Village of Arlington Heights
Plan Commission
Board Room
Arlington Heights Village Hall
33 S. Arlington Heights Road
Arlington Heights, IL 60005
November 5, 2015
7:30 PM

Item: 13 E. Miner St. Development - PC#15-013

To: Plan Commission
Prepared By: Bill Enright, Deputy Director Planning and Community Development
Meeting Date: November 5, 2015
Date Prepared: October 29, 2015
Project Title: 13 E. Miner Street Development
Address: 13 E. Miner Street (vacant lot)

PLAN COMMISSION PC #15-013
Miner Street Development
13 E. Miner Street
Planned Unit Development
Round 1

EASEMENT SITE PLAN SCALE 1"=10'-0"

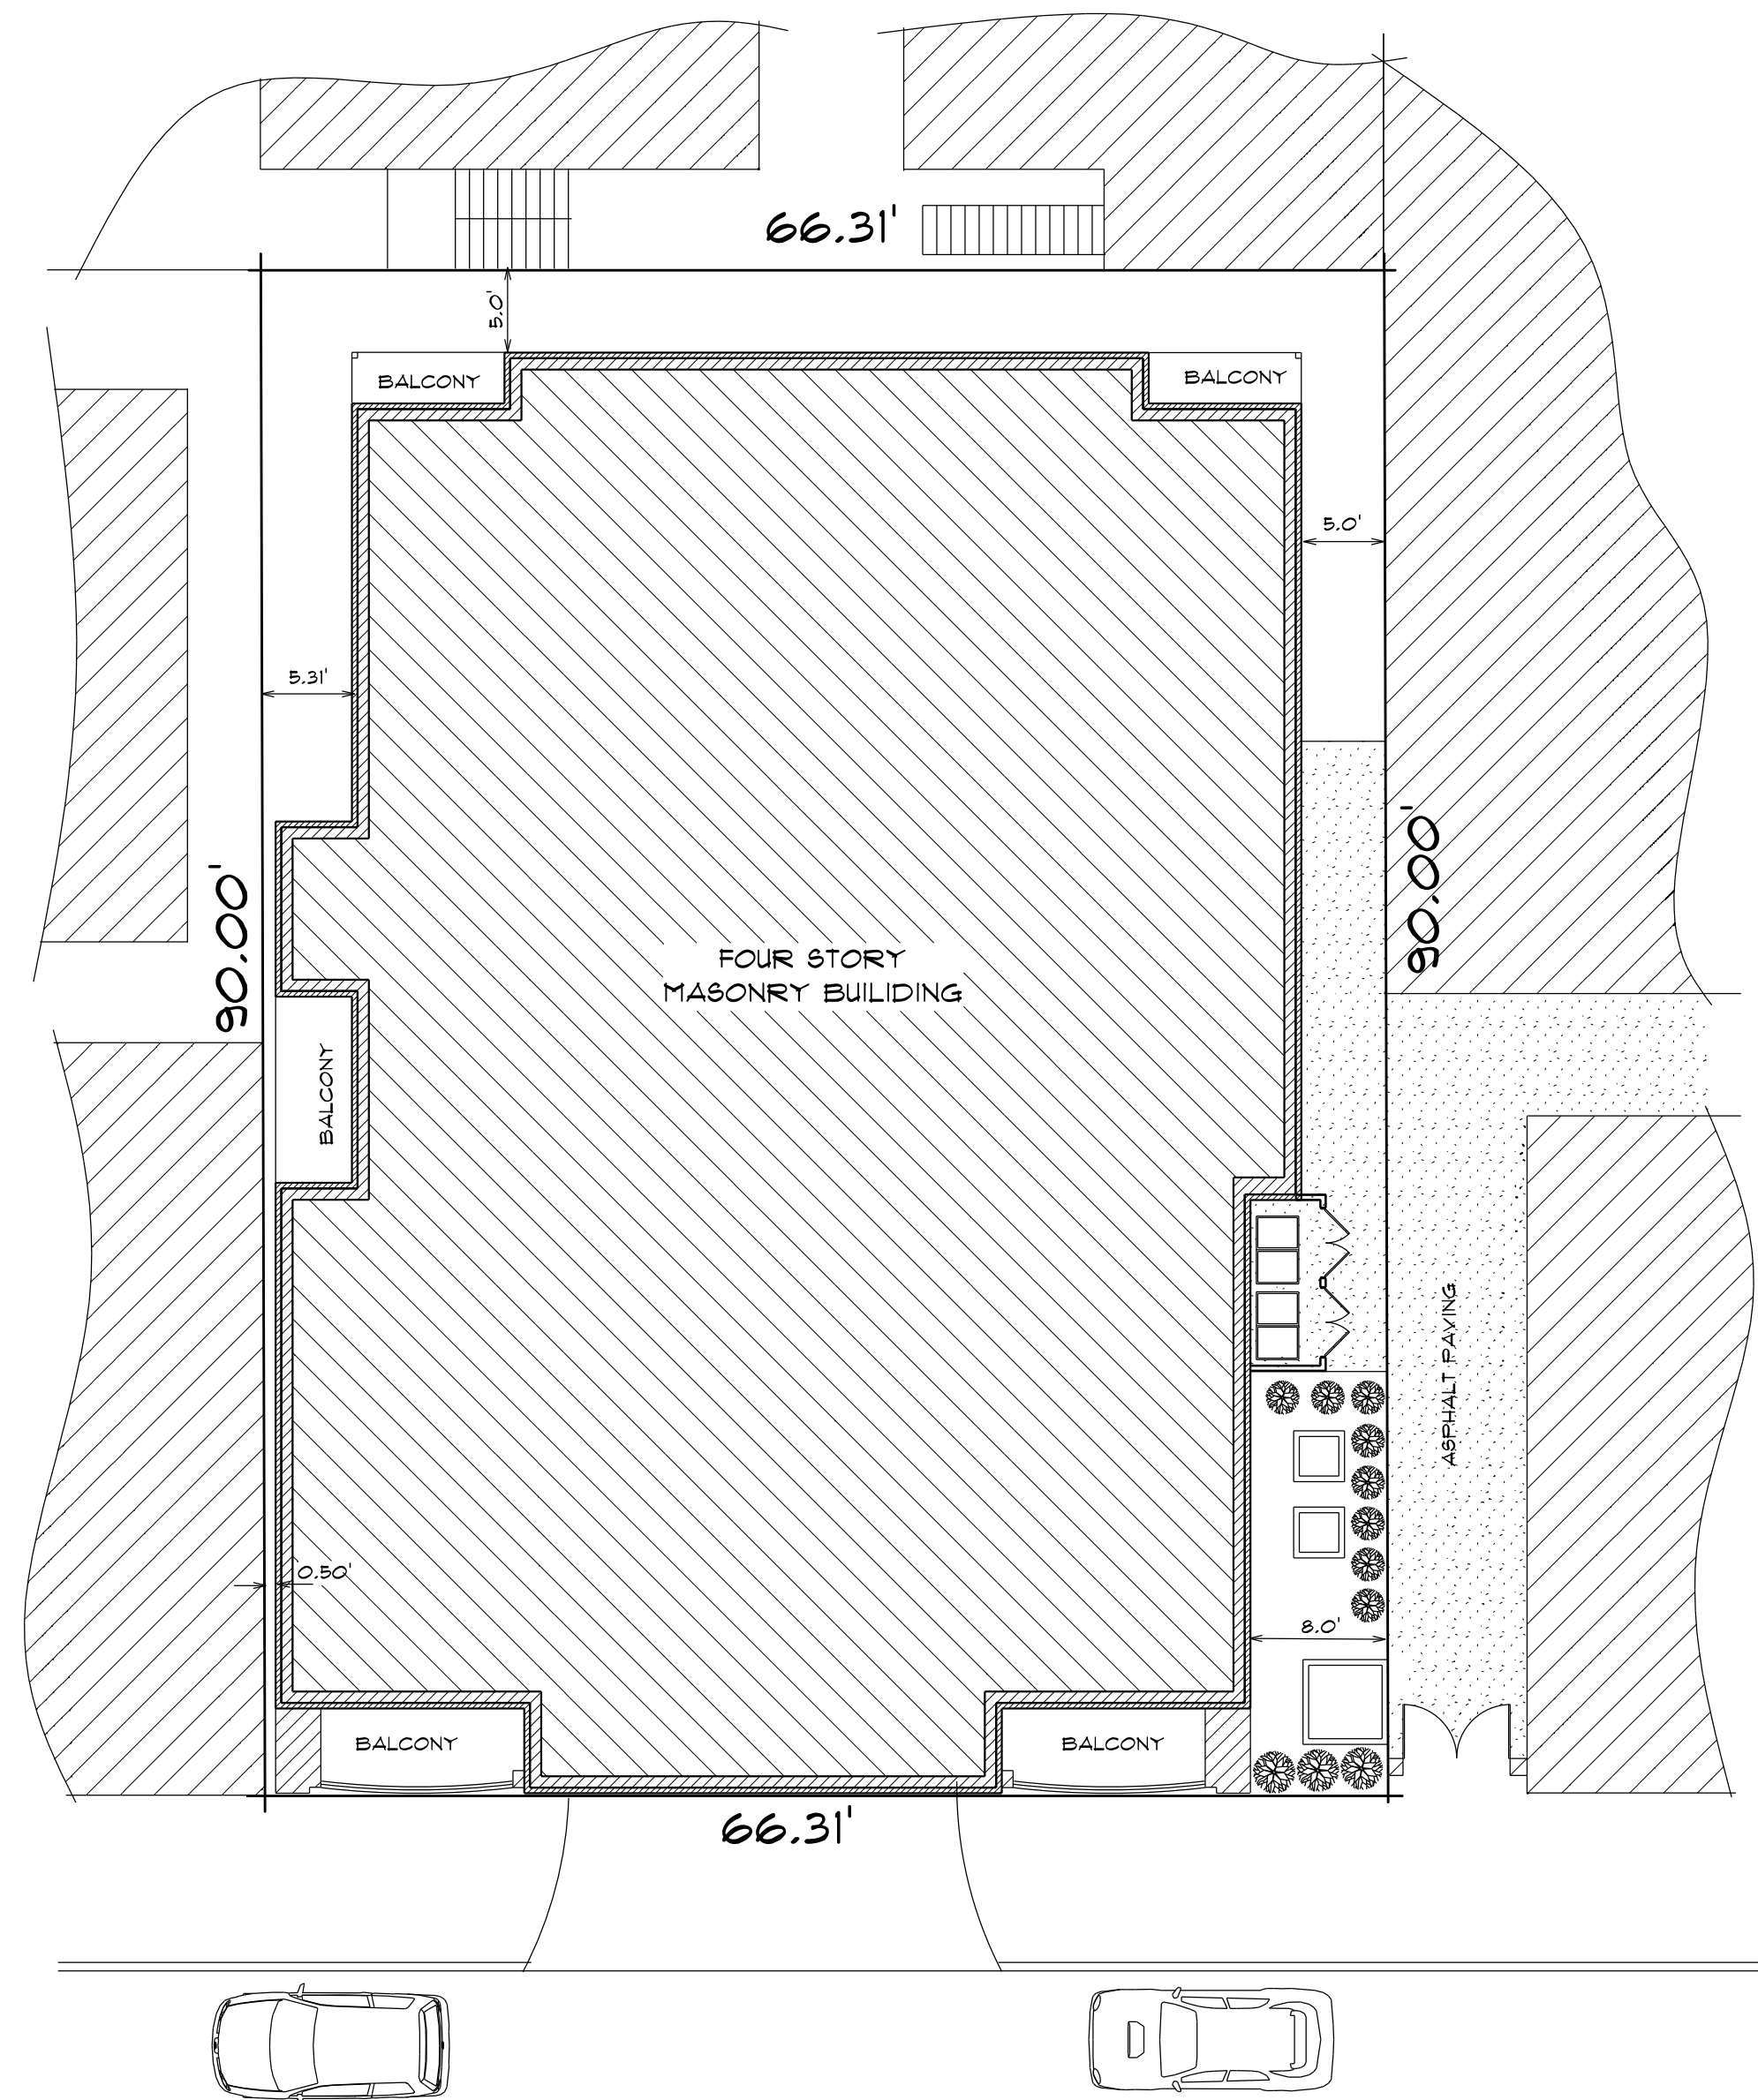
The plans include a 5.81 foot west yard setback and 0 feet east yard setback. Staff supports this variation as the building meets the required building code requirements and as an infill development, meeting the required setback would be excessively restrictive. It should be noted that ComEd is currently formally reviewing the 5 foot easement around the building. ComEd has verbally stated that they think this will be sufficient for providing their services. Staff is requiring that as part of Final PUD review, that the petitioner submit a Plat of Easement signed by ComEd and any other necessary utility companies. This will ensure what is required as it will take about 12 to 16 weeks for ComEd to review the plans for this development (petitioner submitted to ComEd the building plans September 24th).

There are several Commonwealth Edison power poles along the west property line of the subject site. These existing overhead power lines provide service to the subject site as well as the surrounding properties. In conjunction with the proposed development, the Petitioner is planning to move the services to an area at the northwest corner of the property and provide an easement along the west, south and a portion of the east property. Also, the water and sanitary sewer services servicing 12 and 18 - 24 E. Northwest Highway traverse through this site (13 E. Miner) to Miner Street and would need to be relocated, as will utility connects for 15-19 E. Miner to the east.. A viable solution for all parties must be developed.

8. Prior to Final Planned Unit Development, the petitioner shall submit a signed Plat of Easement for Com Ed and any other utility companies requiring said easement.

LEFT ELEVATION

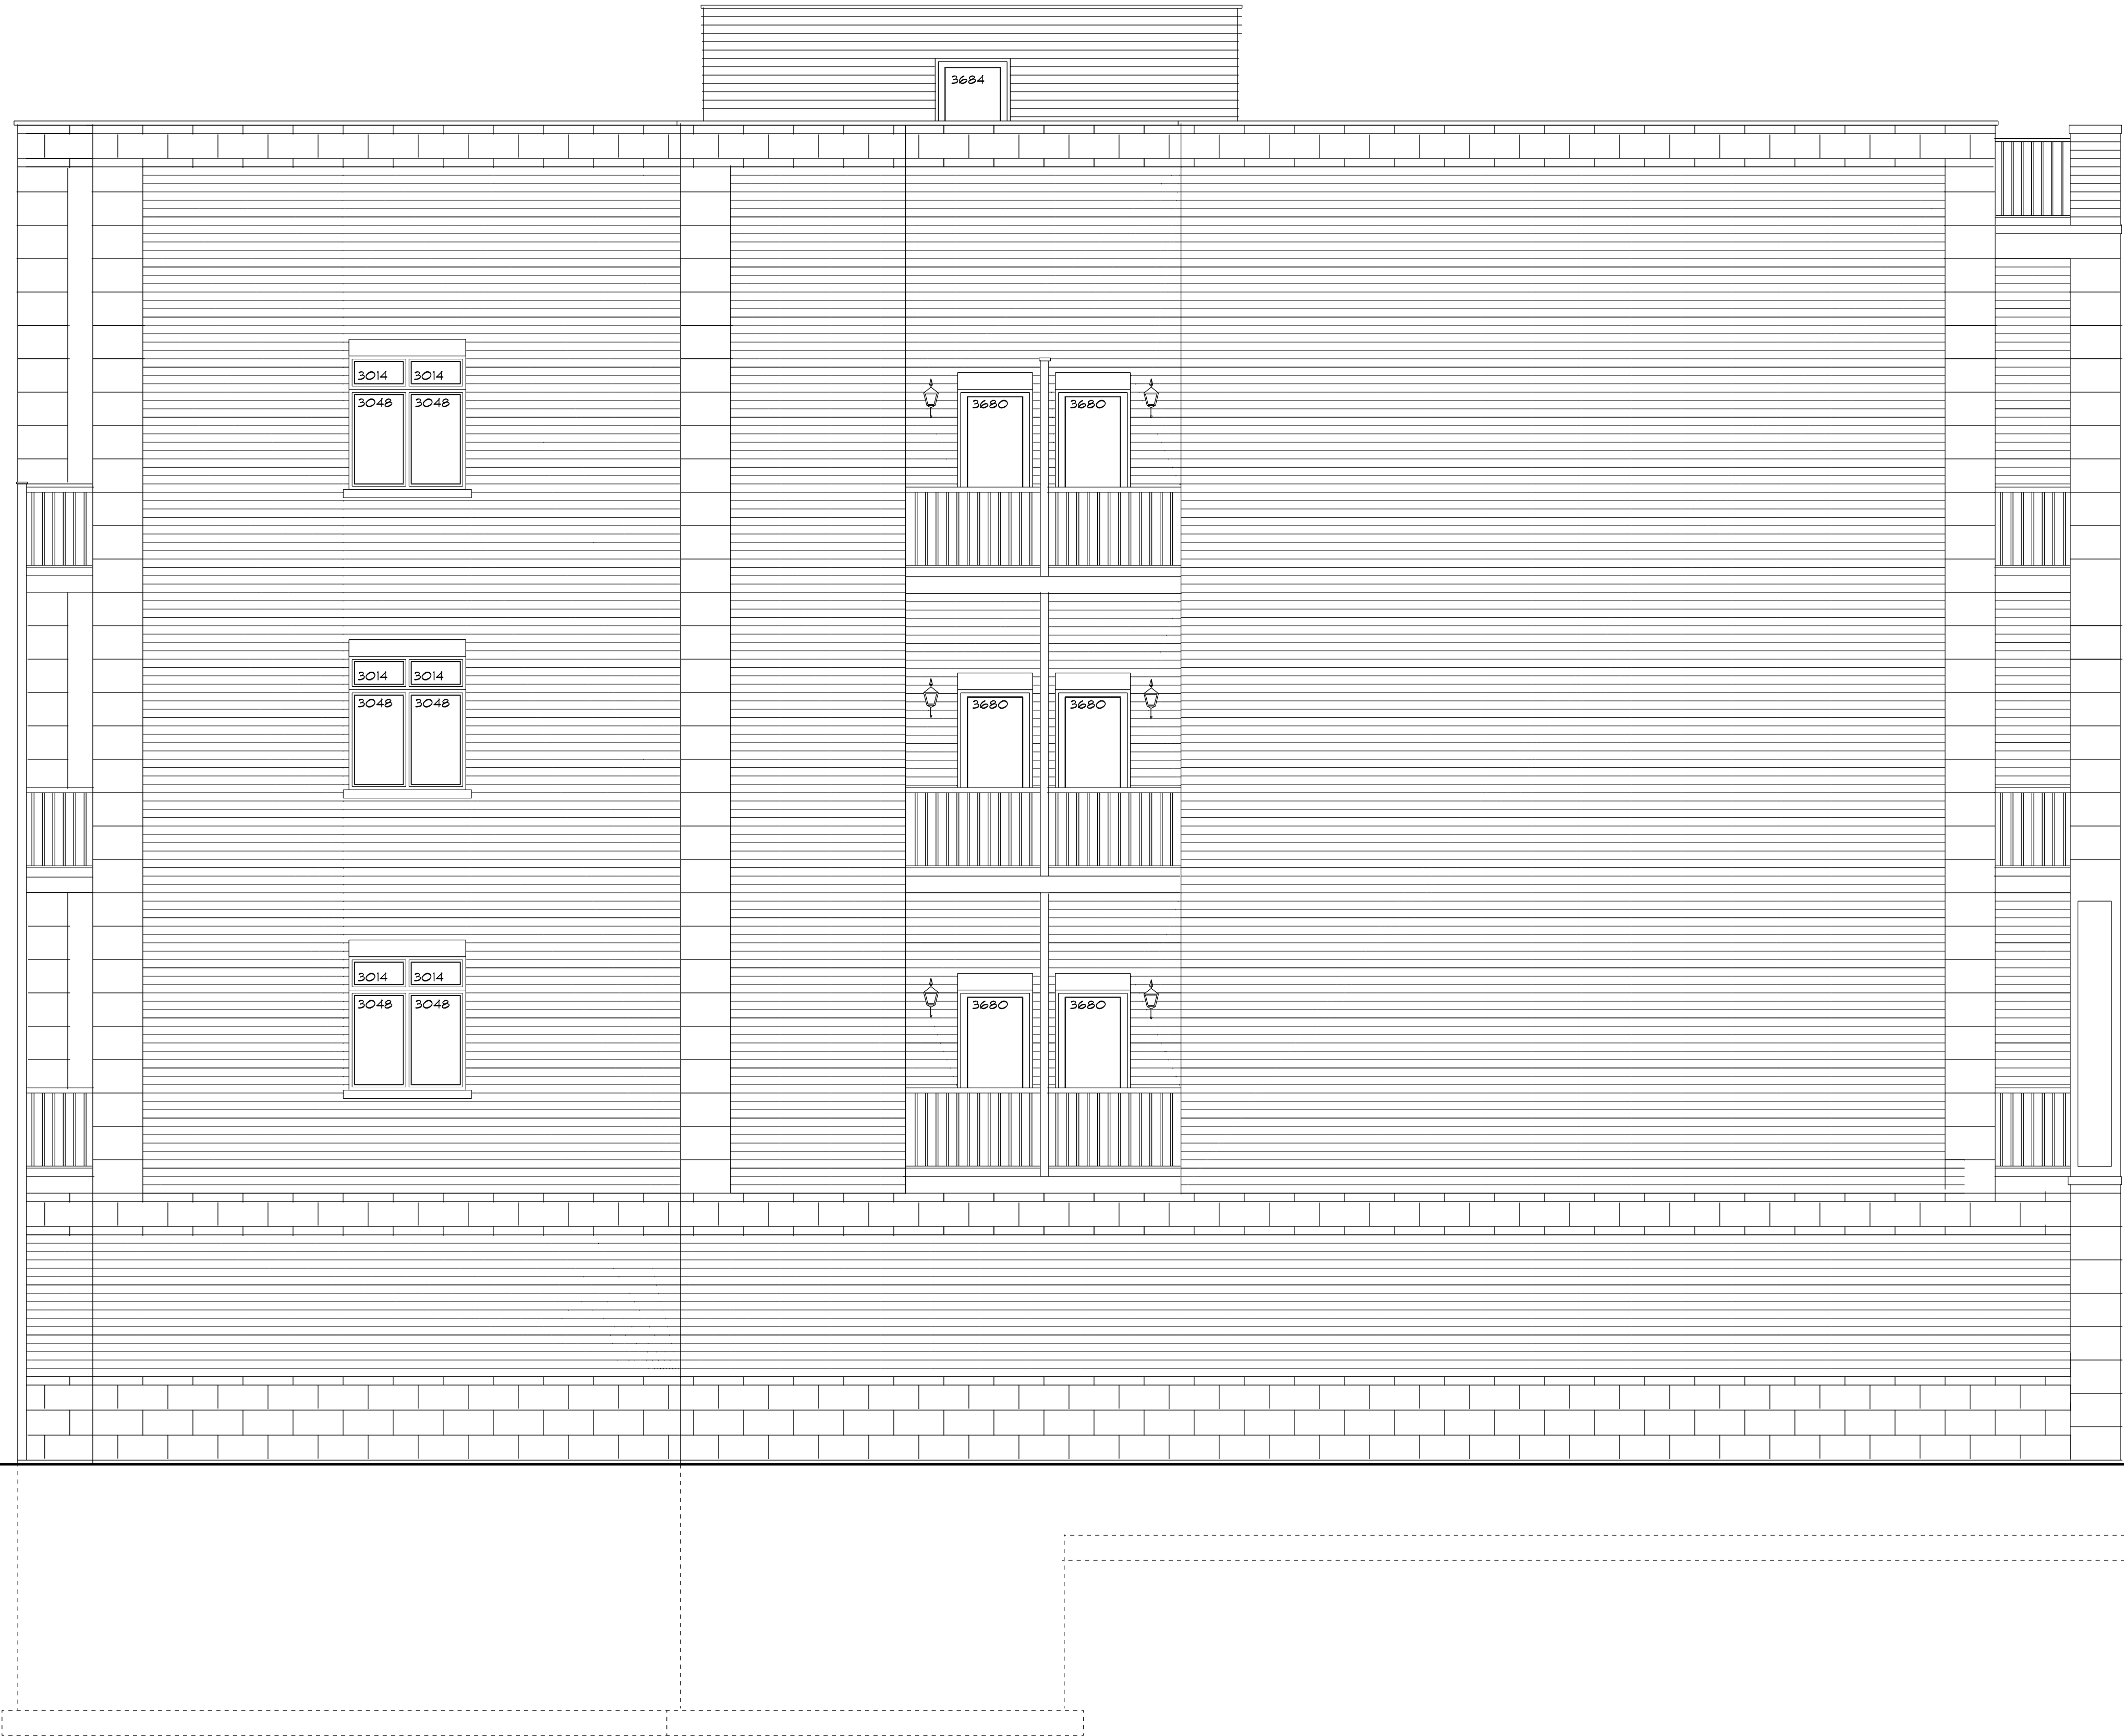
1. Consider continuing the roof deck railing detail from the front elevation down the side elevations.
2. Preliminary building code review concludes that the three windows shown on the left (east) elevation are not allowed due to fire separation requirements where the wall is not set back from the lot line. Consider adding more brick and stone detailing to add interest to this large blank wall.
3. The front half of the right (west) elevation is set back eight feet from the property line and will be highly visible. Consider opening the side of the balconies as well as adding windows on this wall.
